APPLICATION NO.	FILING DATE	FIRST NAMED INVENTOR	ATTORNEY DOCKET NO.	CONFIRMATION NO.
10/759,534	01/20/2004	Adolf Weigl	1690.1010	7114

Office Action Summary	Application No. 10/759,534	Applicant(s) WEIGL, ADOLF	
	Examiner Gene L. Bankhead	Art Unit 3744

DETAILED ACTION

Figure A (Higo)

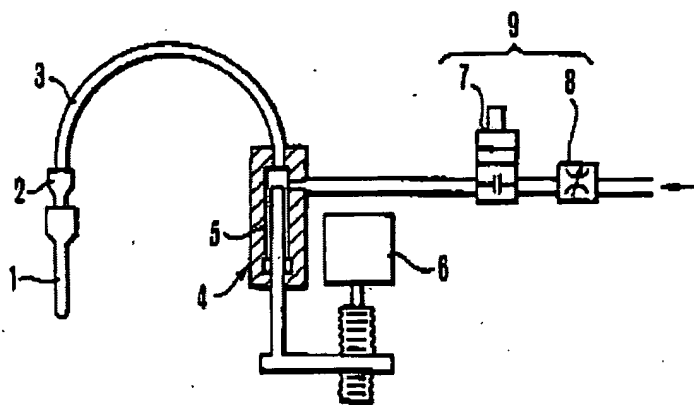
Regarding claims 3 and 4 the injection device, Figure A below, comprises:

A reservoir 5 capable of storing an antibacterial substance, an injection pump 4 activated electrically by the control device (column 4 lines 6-23) and at least one nozzle head 2 connected to an outlet of the injection pump via a pipeline 3. The injection pump

has a compressible volume filled with active substance and an actuation mechanism capable of the abrupt compression of the volume (column 1 lines 50- 68 and column 4 lines 7-24).

With regards to claim 8, the nozzle holder 2 joins the nozzle head 1 and the pipeline, (see Figure A).

Figure A (Higo)

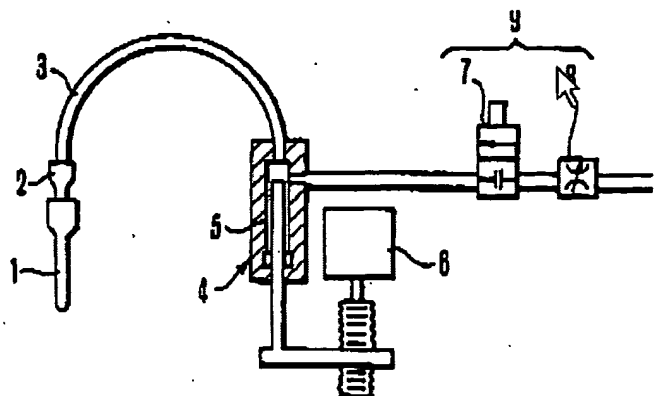
Claims 5-7 are rejected under 35 U.S.C. 103(a) as being unpatentable over Higo. Higo discloses all limitations of claim 2 as previously stated. Higo does not expressly disclose however non-return valve arranged between the outlet of the injection pump and the nozzle head. Instead, Higo discloses the non-return valve 8 and the nozzle head situated on opposite sides of the injection pump, see Figure A below.

At the time the invention was made, it would have been an obvious matter of design choice to a person of ordinary skill in the art to place a non-return valve between the outlet of the injection pump and the nozzle head. Applicant has not disclosed that placing the non-return valve between the outlet of the injection pump and the nozzle head provides an added advantage, has a particular purpose, or is a solution to a stated problem. One of ordinary skill in the art would have expected the claimed invention to function equally well with the non-return valve between the injection pump and nozzle head or the injection pump between the non-return valve and the nozzle head.

Figure B (Benalikhoudja)

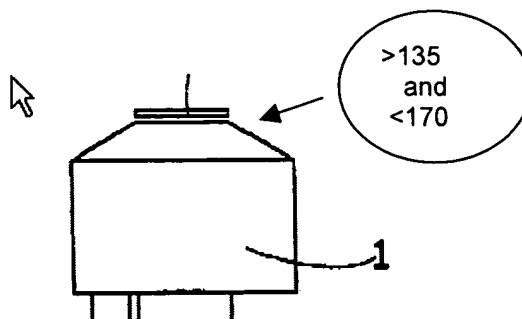
Claim 9 is rejected under 35 U.S.C. 103(a) as being unpatentable over Higo in view of Benalikhoudja (US 6405944). Claim 9 differs from Higo in calling for a nozzle head with a spray cone with an opening angle of between 135 and 170 degrees. Benalikhoudja discloses a spray cone 1; see Figure B below,

with an opening angle between 135 and 170 degrees (column 3 lines 20-28). The spray cone is a nebulization device suited to produce liquid particles having different viscosities and extremely small dimensions, and to diffuse them in order to form a spray or an aerosol (column 4 lines 4-10). Benalikhoudja teaches the discharge of large particles from nebulization devices leads to unnecessary loss of fluid and can be very costly (column 1 lines 40-45). Therefore it would have been obvious to one of ordinary skill in the art at the time of the invention to modify the nozzle head of Higo with Benalikhoudja because the nozzles geometric shape enables it to trap large particles, and thus prevent any axial exit of the spray (column 1 lines 45-51 and column 2 lines 25-67 and column 3 lines 1-32).

Figure C (Brickley)

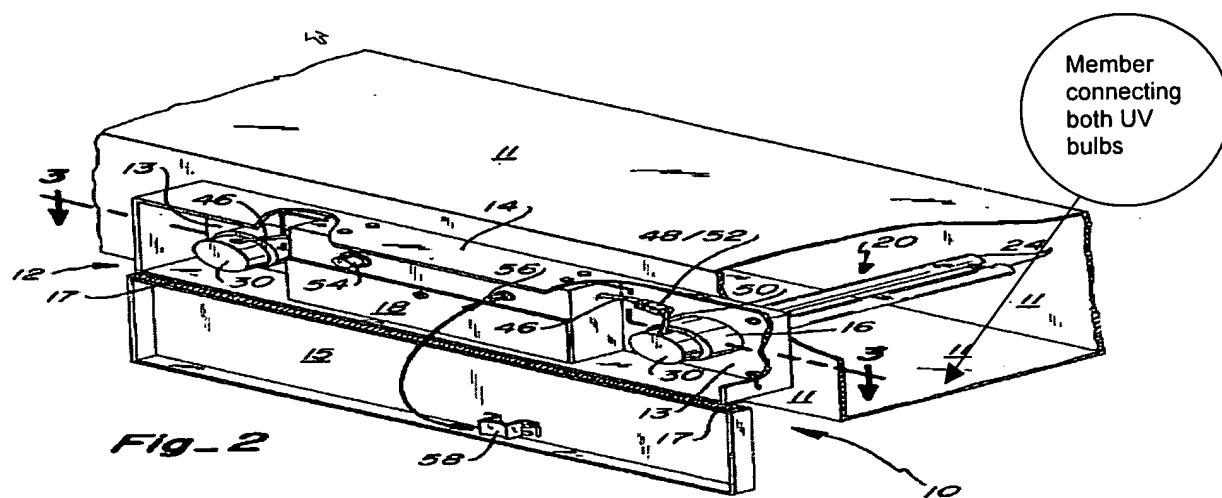
Claims 24 and 34 are rejected under 35 U.S.C. 103(a) as being unpatentable over Higo in view of Brickley (US 5902552). Claim 24 differs from Higo in calling for a

UV lamp. Brickley discloses an ultraviolet air sterilization device 10, with removable UV lamps 20. The lamps are mounted on receptacles 30 and are aligned in an air stream of an air-handling unit duct 11 (column 2 lines 1-35). It is well known in the art ultraviolet light sources are an excellent means for killing bacteria and microorganisms in air streams. Therefore it would have been obvious to one of ordinary skill in the art at the time of the invention to incorporate the removable UV lamps of Brickley into the injection device of Higo in order to clean and sterilize the air circulating through commonly used closed spaces for air conditioners, such as offices and hospitals.

Figure D (Elmore)

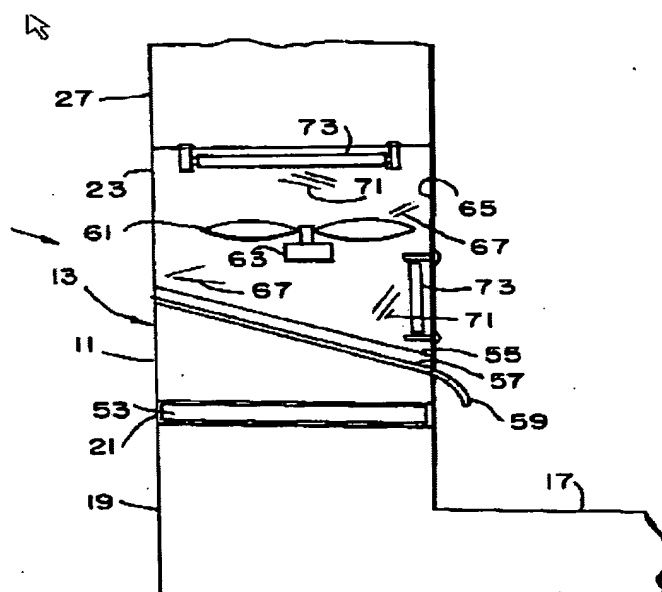
Claims 25 and 26 are rejected under 35 U.S.C. 103(a) as being unpatentable over Higo in view of Elmore (US5558158). Claim 25 differs from Higo in calling for an UV lamp with air guide elements. Elmore discloses UV lamps 73 in a duct 17. Elmore further discloses air guide elements, 67, 59, and 53, that partially inhibit smooth airflow past the UV lamps and partially prolong the dwell time of the air in the region of the lamp, see Figure D below. It is well known in the art ultraviolet radiation is an excellent means of killing bacteria and harmful biological material in airstreams. Therefore it would have been obvious to one of ordinary skill in the art to at the time of the invention to incorporate the ultraviolet lamps of Elmore into the injection device to thoroughly clean and purify air that flows through common air conditioning systems, such as those in schools and laboratories.
